STATE OF MAINE
DEPARTMENT OF TRANSPORTATION
16 STATE HOUSE STATION
AUGUSTA, MAINE
04333-0016

November 13, 2009
Subject: **Trenton, Acadia Welcome
Center**
Federal Project No: 16123.50
State Pin No: 016123.50
Amendment No. 7

Make the following changes to the Bid Documents:

Figure No. **CSK-2**

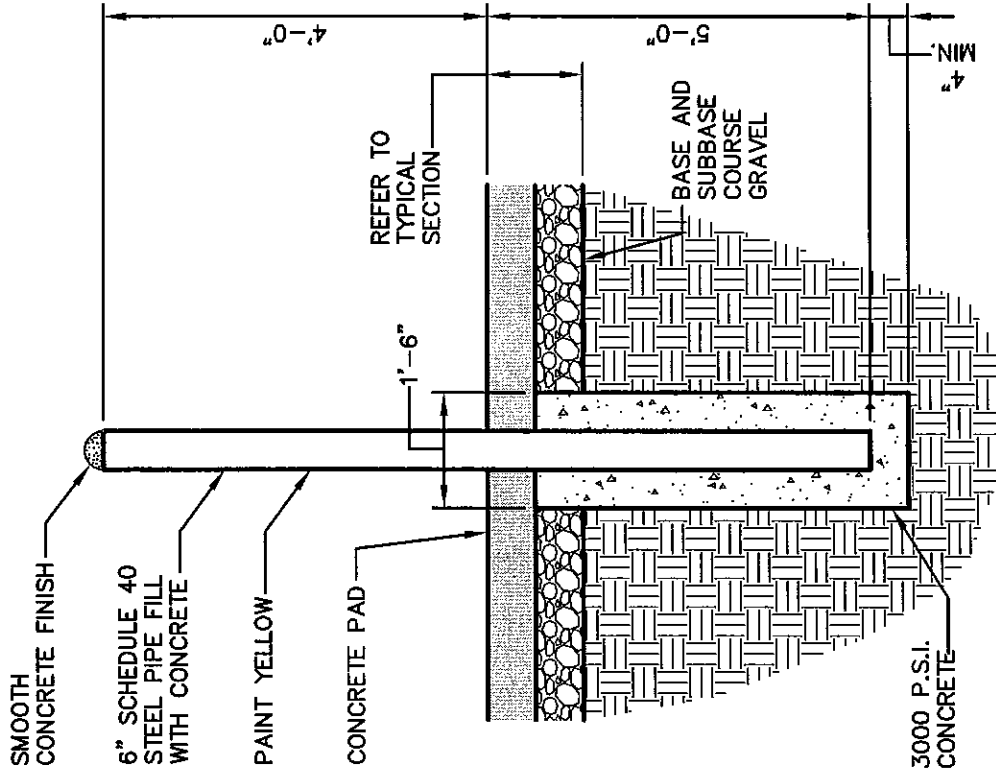
E. At the end of the plans, **ADD** the attached drawings, Figure No. CSK-2, titled “Utility Protection Bollards”, 2 pages.

Question#8: There are no bollards or fencing shown around your 18,000 Gallon LP Tank. Do you require any protection around this tank?

Response: Yes, tank requires bollards and fencing. Bollard location and installation detail are depicted on CSK2 attached in this amendment. Refer to Sheet A1.01 for extent of fencing. Refer to Civil Drawings for additional details
